Planning Commission Meeting

PLANNING COMMISSION AGENDA

Development Review Committee Minutes

On October 7, 2024, plans were submitted for the Harmony Ridge Plat "G" subdivision consisting of 113 townhome lots. The items below include 1) requested changes to the submitted plans, 2) other items required as part of the application and/or 3) informational items regarding city standards.

LEFT SIDE ELEVATION
SCALE 1/4" = 1'-0"

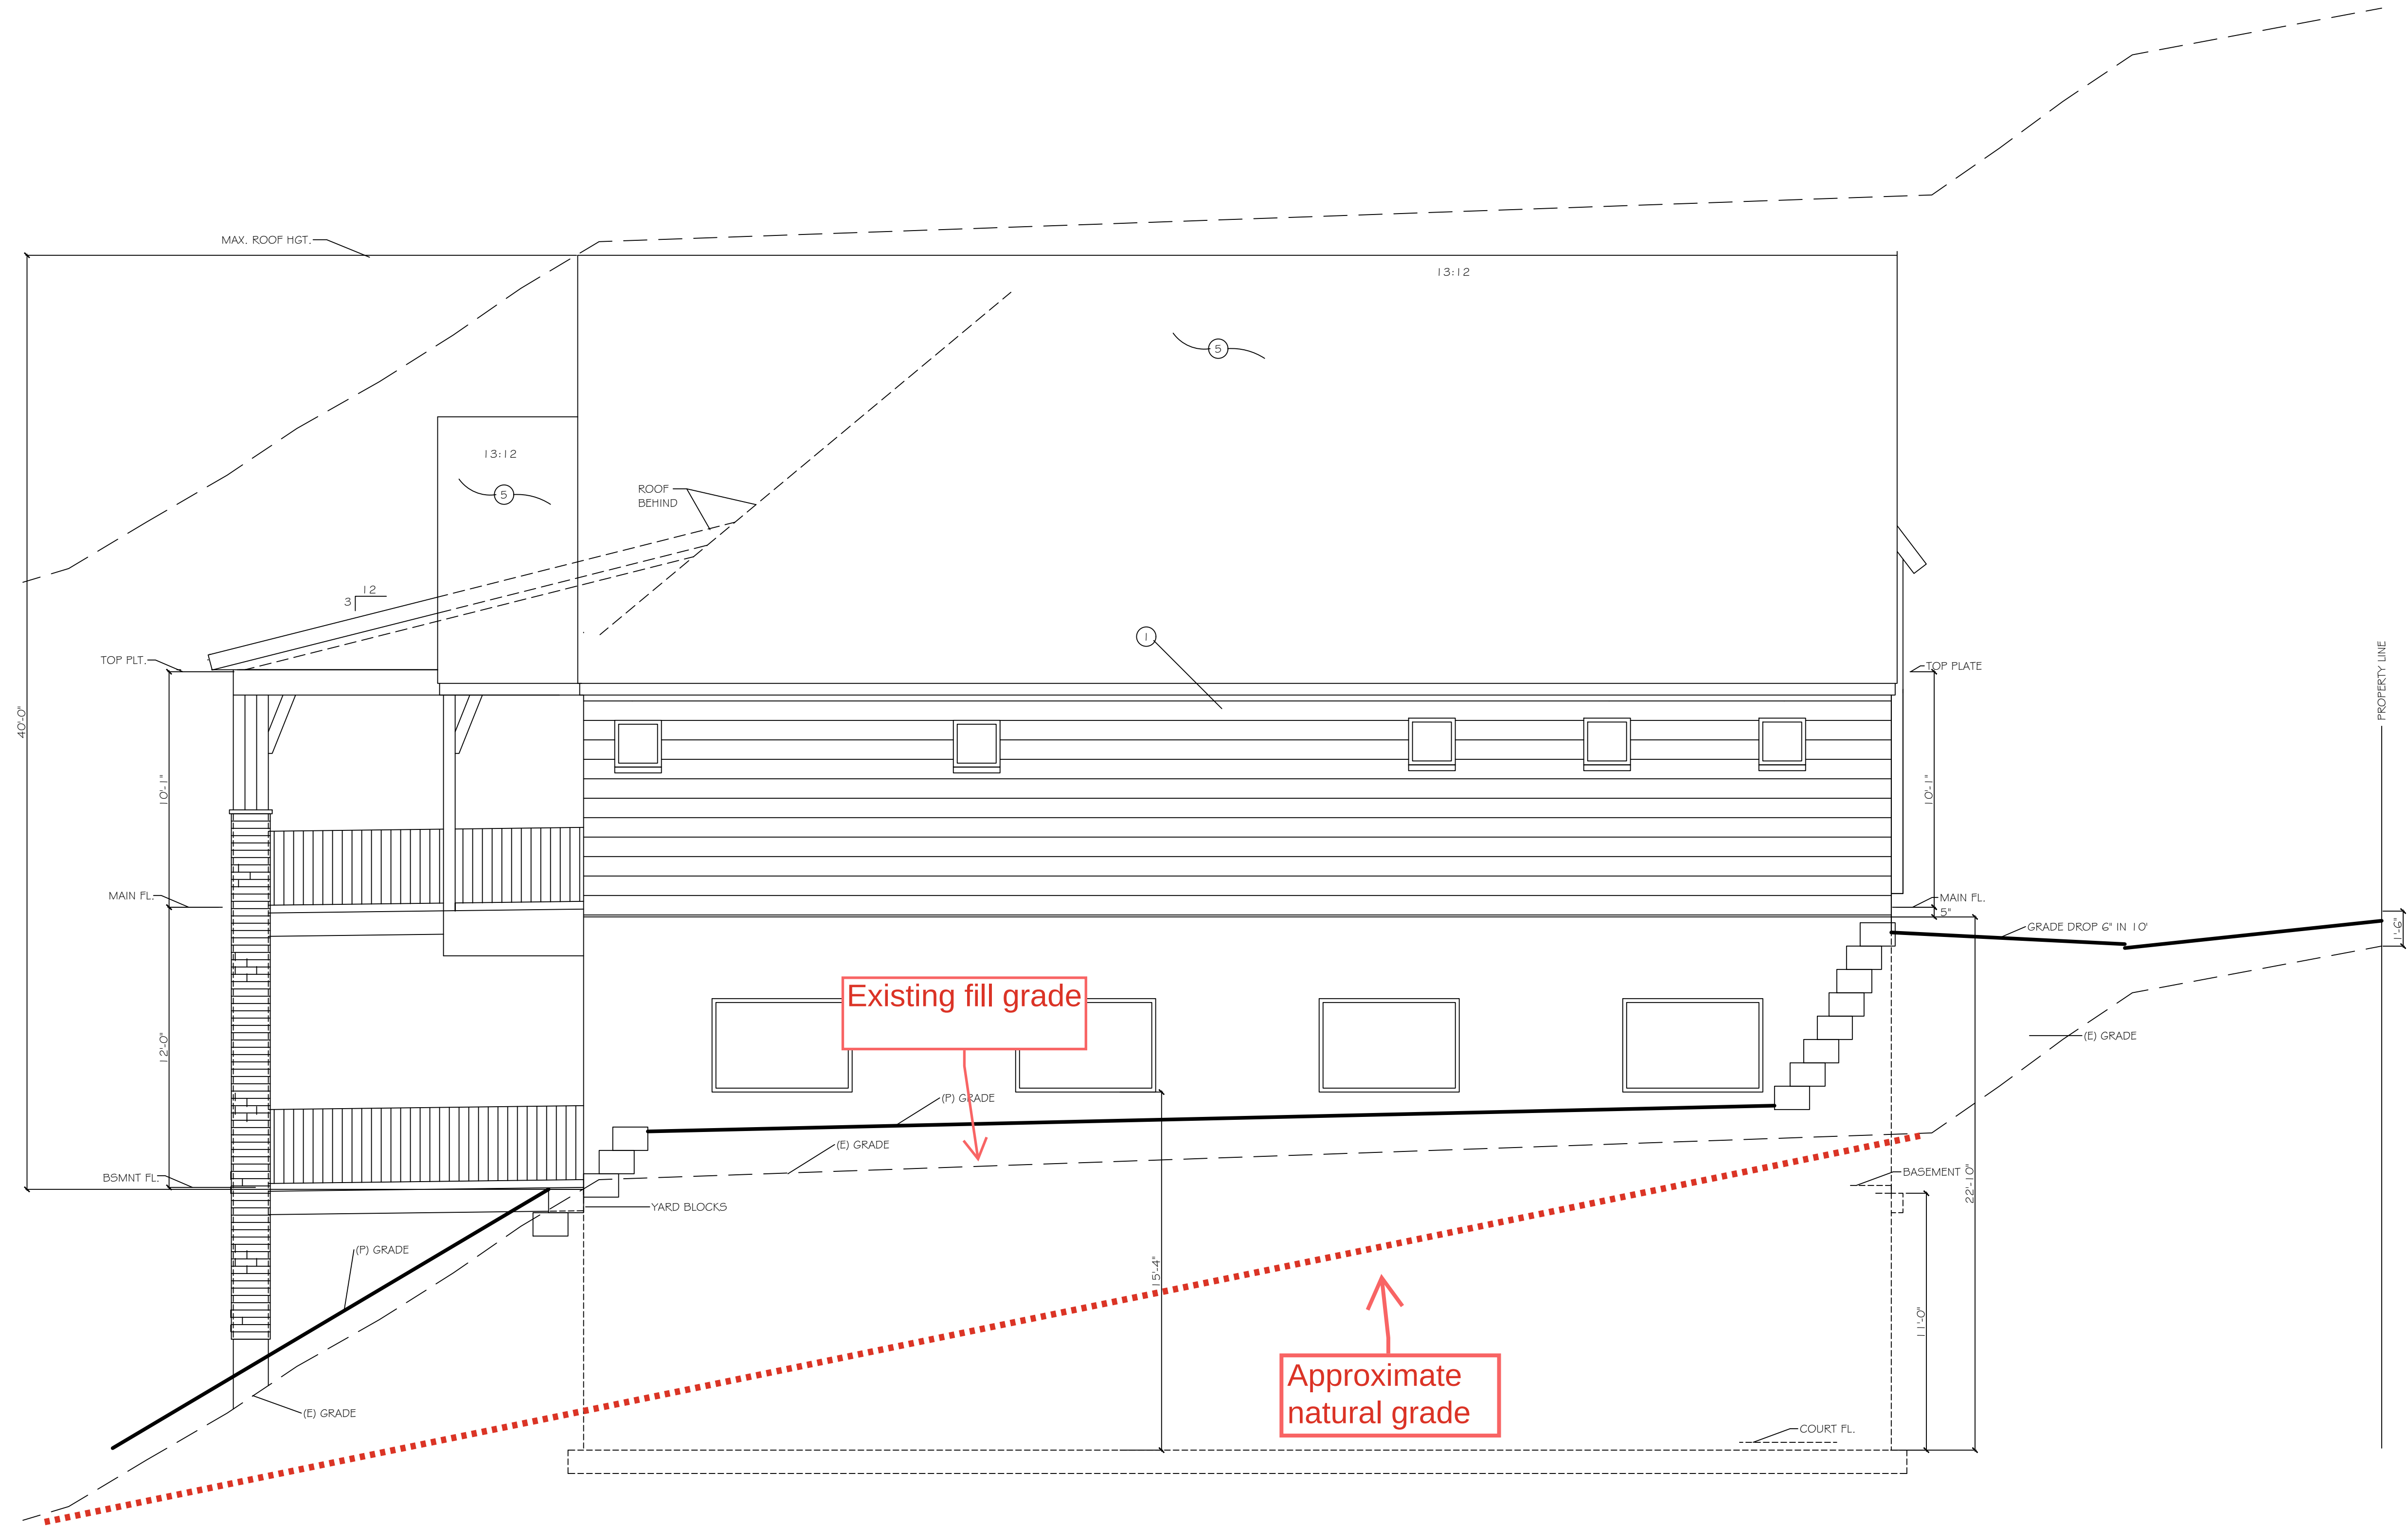
Response: Height limitations are meant to reduce mass and bulk and maintain an aesthetic environment from the street. Given that the proposed dwelling will be less than 40 feet in height above Troy Street, it appears the spirit of the land use ordinance will be observed. Staff does recommend that the dwelling does not exceed 40 feet in height above the elevation of the existing fill. This will help avoid excessive mass as seen from the Krissa Street on the lower side.

would be 40' from existing fill grade.

Grant the variance with the condition that the dwelling not exceed 40 feet in height above the elevation of the existing fill.
